**U.S. DEPARTMENT OF TRANSPORTATION
NATIONAL HIGHWAY TRAFFIC SAFETY ADMINISTRATION**

Federal Motor Vehicle Safety Standards;)	
FMVSS No. 305a Electric-Powered)	Docket No.
Vehicles: Electric Powertrain Integrity)	NHTSA-2024-0012
Global Technical Regulation No. 20,)	
Incorporated by Reference)

**COMMENTS OF THE
TRUCK AND ENGINE MANUFACTURERS ASSOCIATION**

June 14, 2024

Figure 18
Measurement of V_b , V_1 , V_2

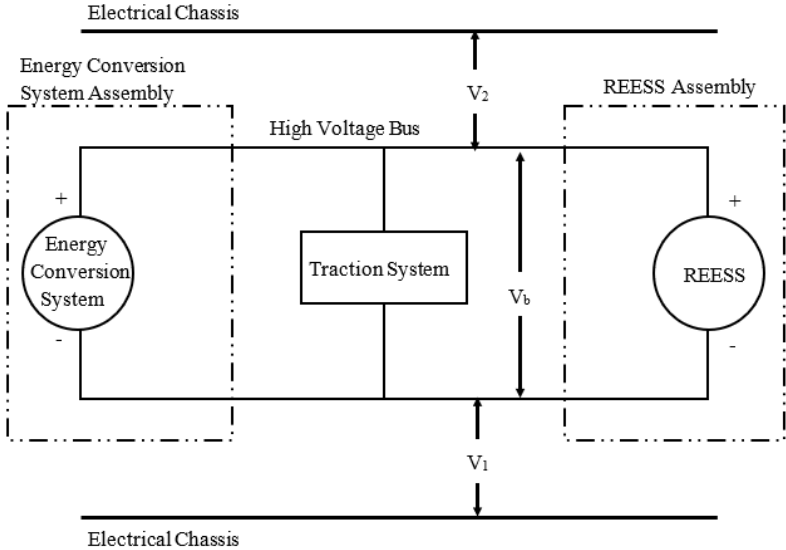
S7.1.2 Working Voltage should be changed to Nominal Voltage.

We request changing “working voltage” to “nominal voltage” in section S7.1.2, as follows:

Working Voltage is the maximum or highest voltage and usually occurs when the vehicle is connected to a charger and fully charged and is not appropriate when performing the crash test. FMVSS No 305a and GTR No. 20 “Working Voltage” definition:

Changing Working Voltage to Nominal Voltage would align with GTR No. 20:

7.1.2 Voltage V_b is measured across the two terminals of the voltage source. Before a vehicle crash test, V_b is equal to or greater than the **working nominal** voltage as specified by the vehicle manufacturer.

The voltage is measured as shown in Figure 18 and the high voltage bus voltage (V_b) is recorded. V_b shall be equal to or greater than the nominal operating voltage of the REESS and/or energy conversion system as specified by the vehicle manufacturer.

While FMVSS No. 305a and GTR No. 20 do not define “Nominal Voltage,” we propose the following definition for “Nominal Voltage”:

Nominal voltage is a value that represents the typical or midpoint of a battery's maximum operating voltage and the minimum operating voltage over its charge and discharge cycle.
